Proposed Changes for PCS Lane Forming

IEEE P802.3bs 400 Gb/s Ethernet Task Force

November 2015 Dallas

Modified TX Block Diagram

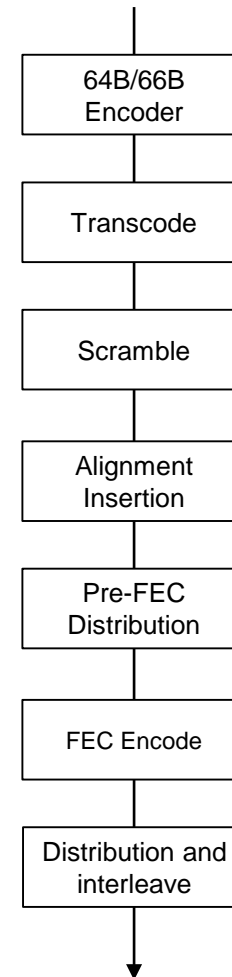
D1.0 TX flow

Proposed new TX flow

Modified RX Block Diagram

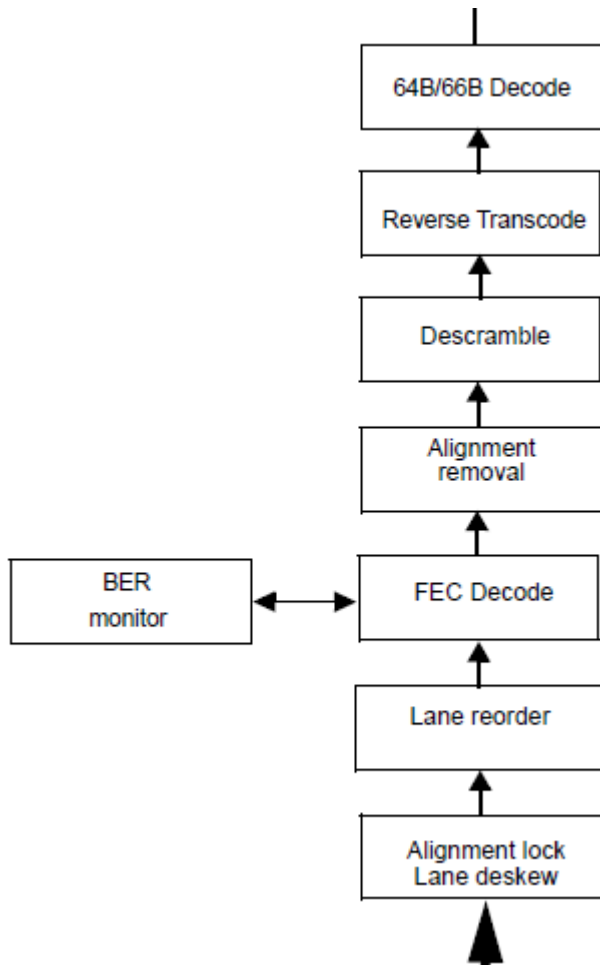
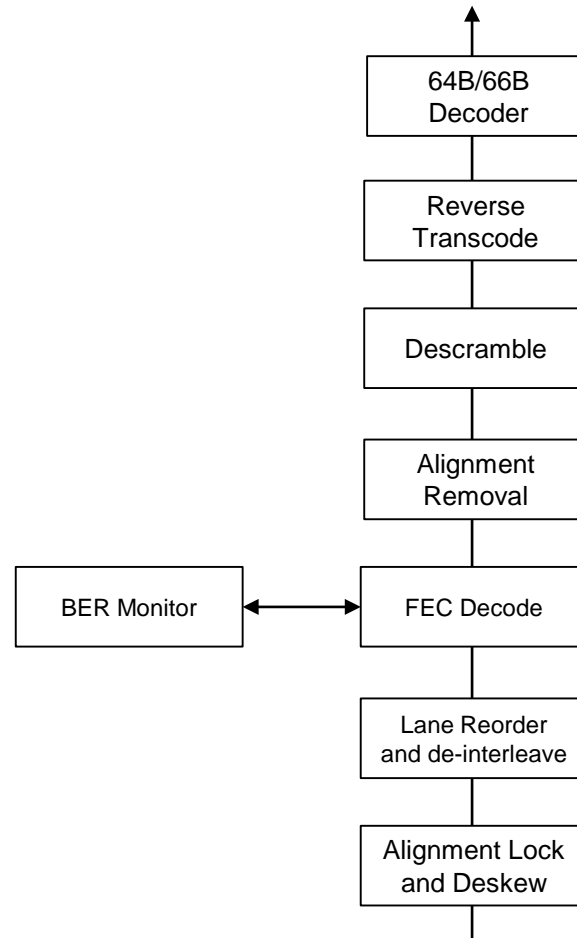
D1.0 RX flow

Proposed new RX flow

Data Into the two Codewords

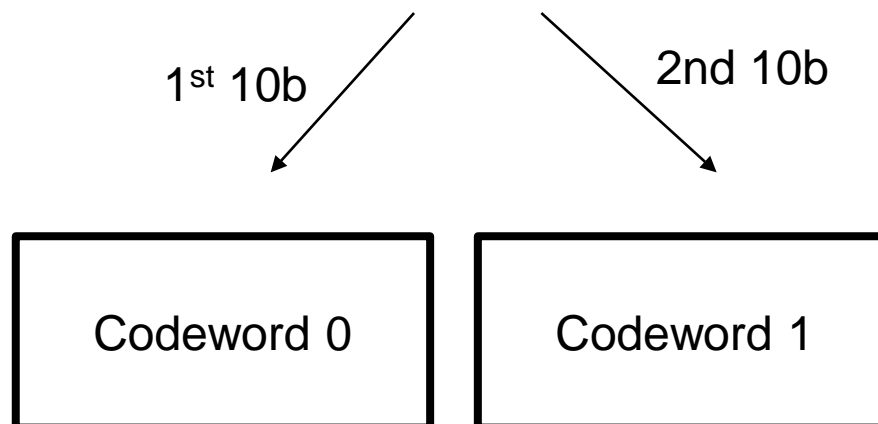
- We looked at parallel and serial filling of the two FEC codewords
- Parallel filling has a small latency advantage, but a small gain disadvantage
- Serial filling is the reverse
- The performance delta was shown in `anslow_01_1015_logic.pdf`
- The latency delta is $\sim 12.5\text{ns}$

- The consensus of the discussions is to do a parallel fill on a 10b striping basis
